ADDENDUM No. One (1)

**Construction, Bridge: County Road 317 over Wilson Creek**

April 23, 2015  
ADDENDUM NO. 1

**CONSTRUCITON, BRIDGE:  
COUNTY ROAD 317 OVER WILSON CREEK**

**BRIDGE LAYOUT**

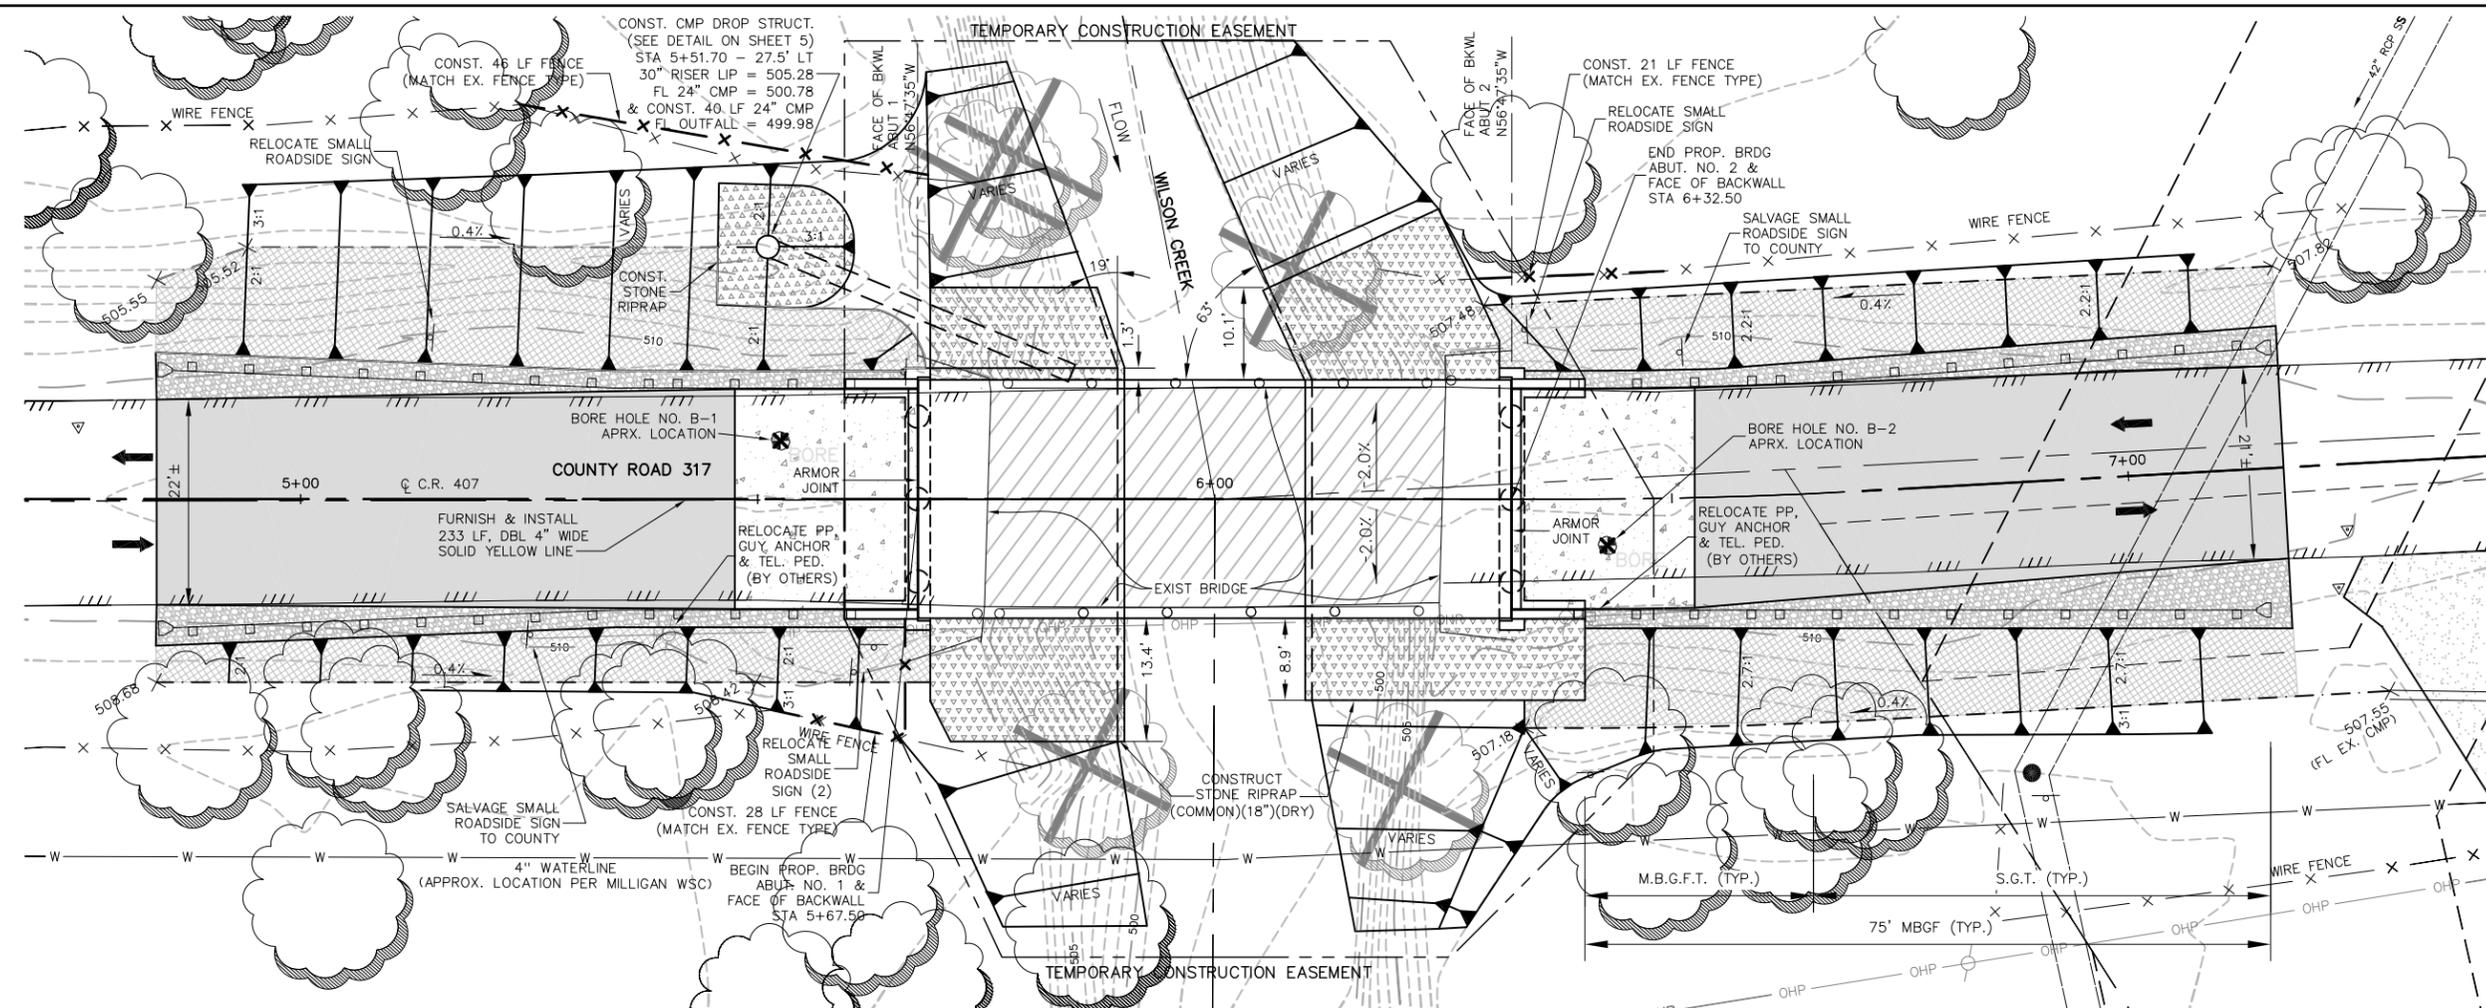
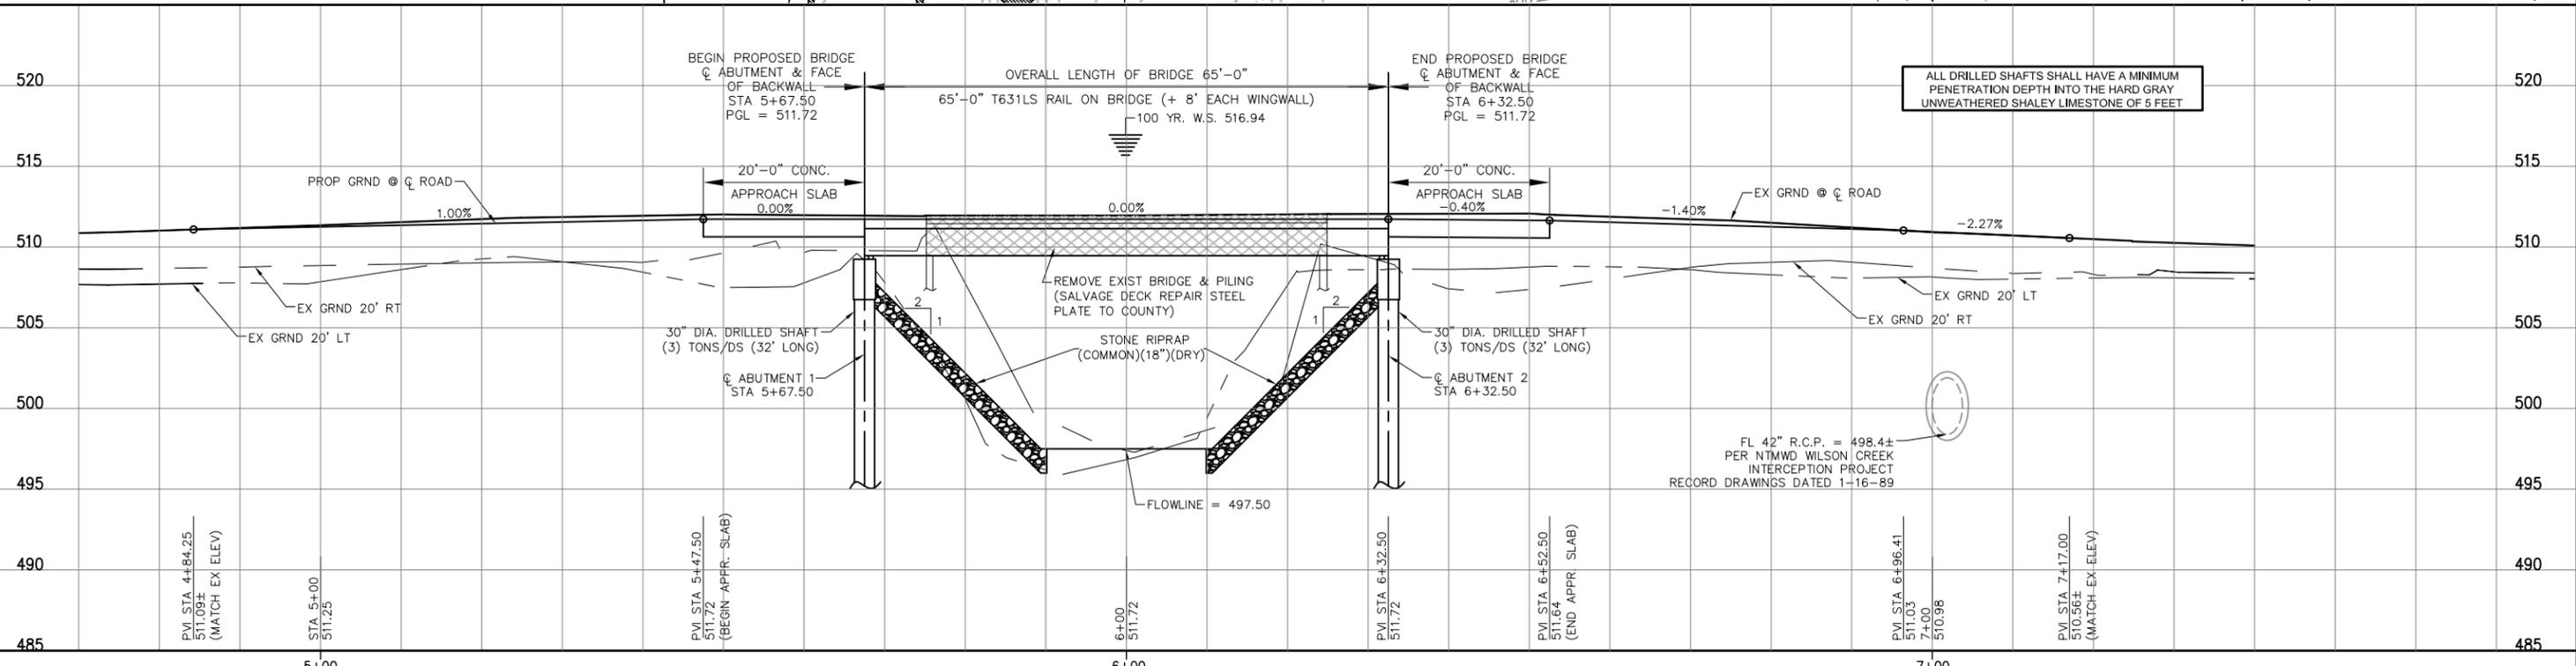
- **Replace Construction Plans, Sheet 07, Bridge Layout with attached Sheet 07**
  - Approximate location of 4" Milligan WSC water line added
- **Replace Bid Proposal Sheet 1 of 7 with attached Sheet 1 of 7**
  - Quantity for Excavation (Roadway & Channel) is revised from 325 to 355 CY
  - Quantity for Embank (Final) (Dens Cont Ty B) is revised from 75 to 145 CY
- **Replace Bid Proposal Sheet 5 of 7 with attached Sheet 5 of 7**
  - Quantity for Barricades, Signs and Traf Handling is revised from 4 to 5 Months
  - Construction Time remains unchanged at 120 calendar days
